CSR LIMITED

18 January 2021

BADGERYS CREEK QUARRY AND BRICK MAKING PROJECT (MP10_0014)
UPDATED STAGING PLAN – SCHEDULE 5 CONDITION 6

Figure 2
Preferred Project: Phase 1 - Years 1 to 6 (2021 to 2027)

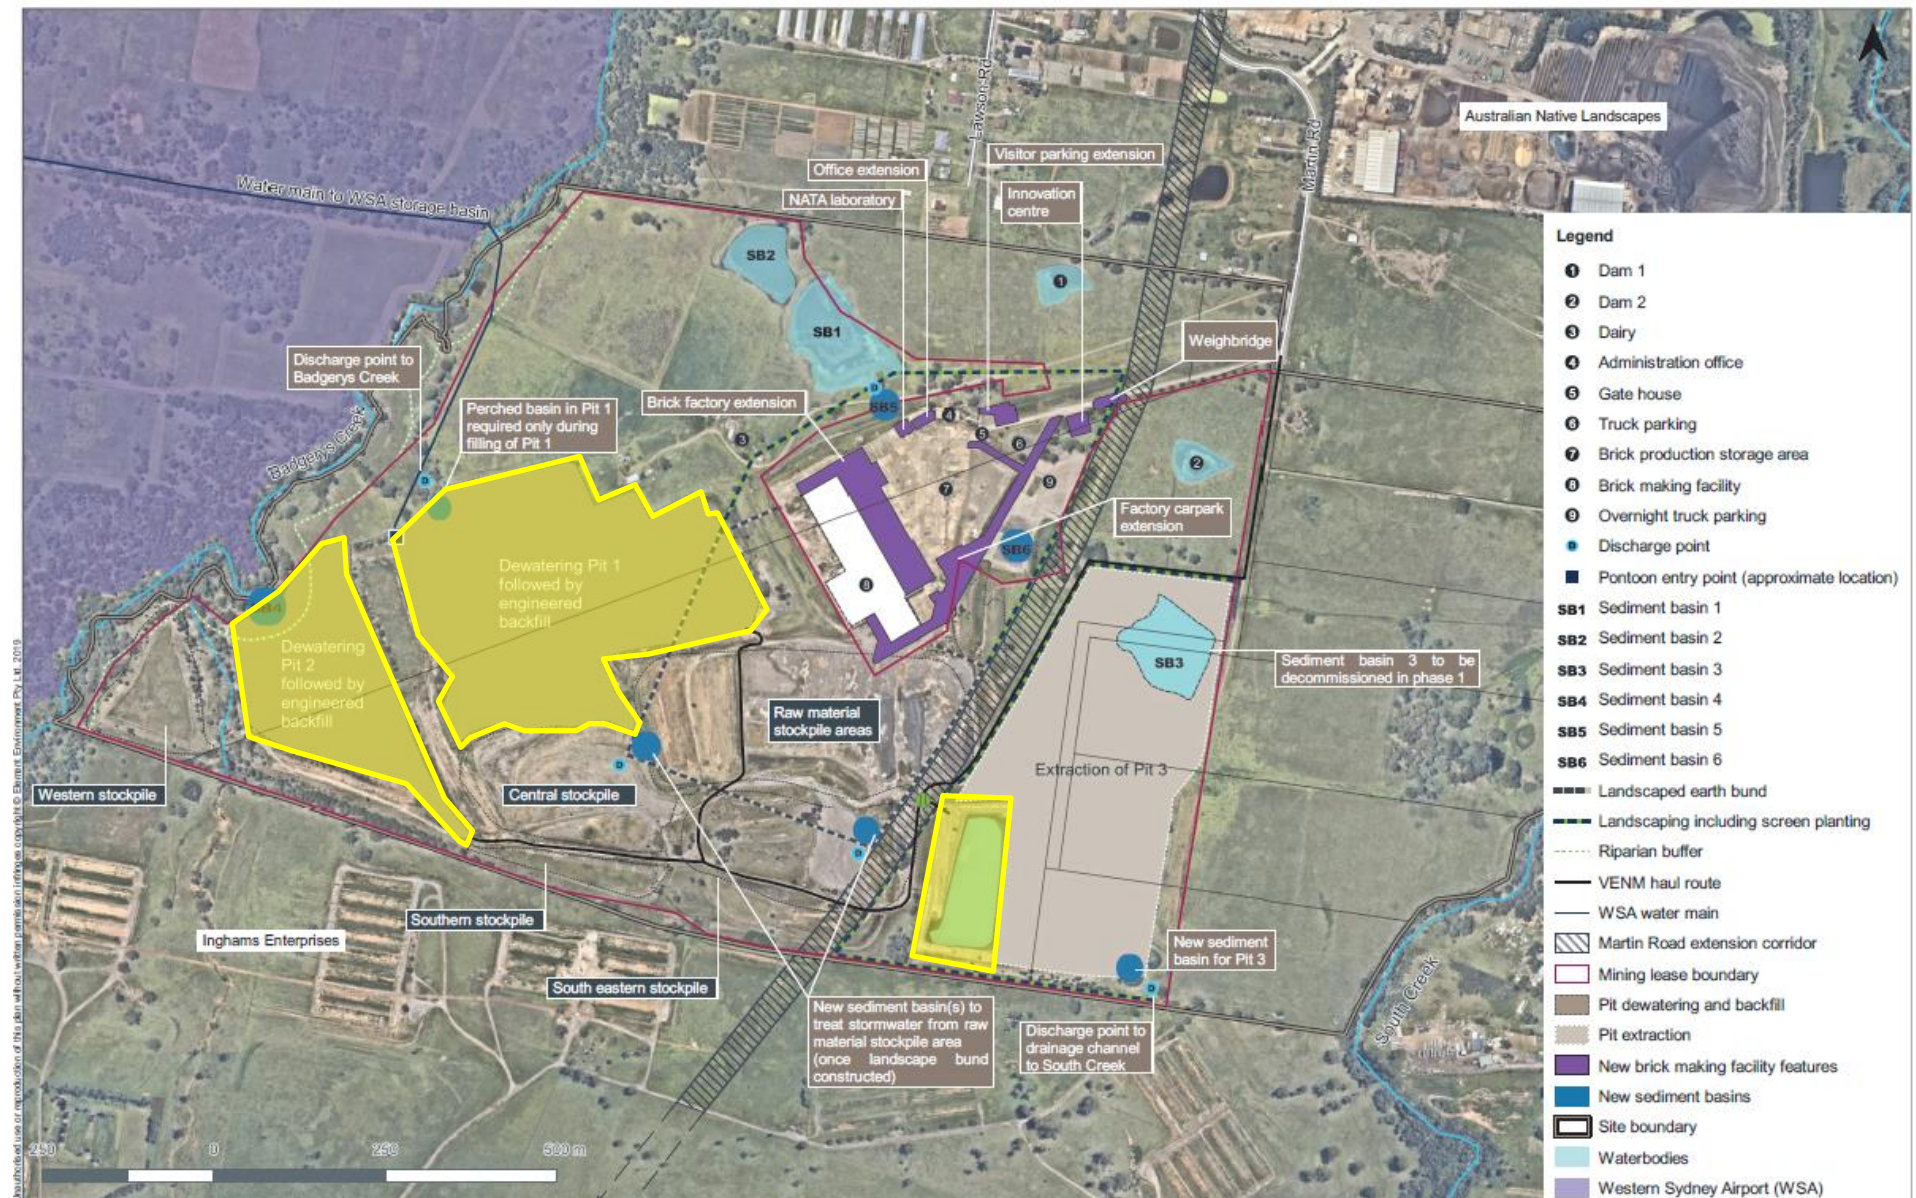
This letter puts forward a revised staging of Phase 1. We proposed to further subdivide Phase 1 into 2 subphases, this is due to a revised strategic review of the site and the prioritisation of the works required.

- *Dewatering of Pits 1,2 and 3*
- *VENM import of quarry rehabilitation activities and preferential backfilling of Pits 1,2 and 3*

Proposed Phase 1a – items highlighted in yellow
